Product / Process Change Notification (PCN)	
<input checked="" type="checkbox"/> Major change <input type="checkbox"/> Minor change	
PCN #: PCN_WL-SUMW_20220316 Affected Series: WL-SUMW; 15335338AA350; 15335339AA350; 15335340AA350 PCN Date: February 25, 2022 Effective Date: March 25, 2022	Change Category: <input type="checkbox"/> Equipment / Location <input type="checkbox"/> General Data <input checked="" type="checkbox"/> Material <input type="checkbox"/> Process <input type="checkbox"/> Product Design <input type="checkbox"/> Shipping / Packaging <input type="checkbox"/> Supplier <input type="checkbox"/> Software
Contact: Product Management Phone: +49 (0) 7942 - 945 5001 Fax: +49 (0) 7942 - 945 5179 E-Mail: pcn.eisos@we-online.com	Data Sheet Change: <input type="checkbox"/> Yes <input checked="" type="checkbox"/> No Attachment: <input type="checkbox"/> Yes <input checked="" type="checkbox"/> No

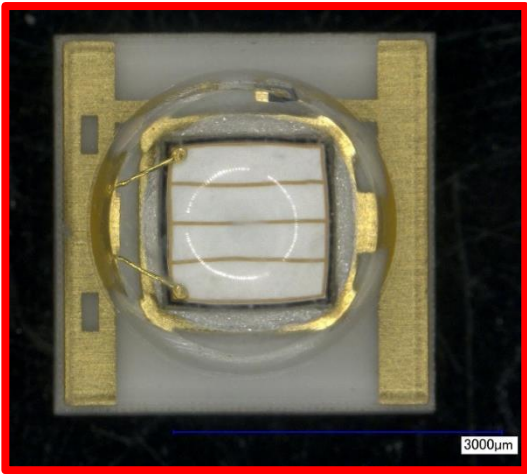
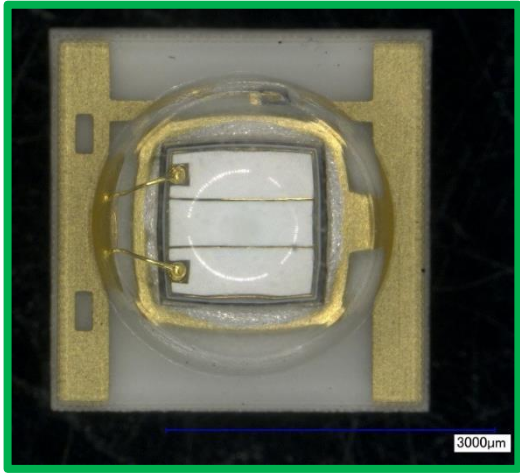
Description and purpose of change: To increase the production capability, Würth Elektronik will change the raw material supplier for the LED chip. All products with date code 2022-02-01 or later, will be affected by this change. There will be no change in fit, function, quality or reliability of the product.	
Detail of Change: The chip will be replaced by a newer chip generation. There will be no change in the dimensions, electrical/optical parameters and reliability of the product.	
BEFORE CHANGE: 	AFTER CHANGE:
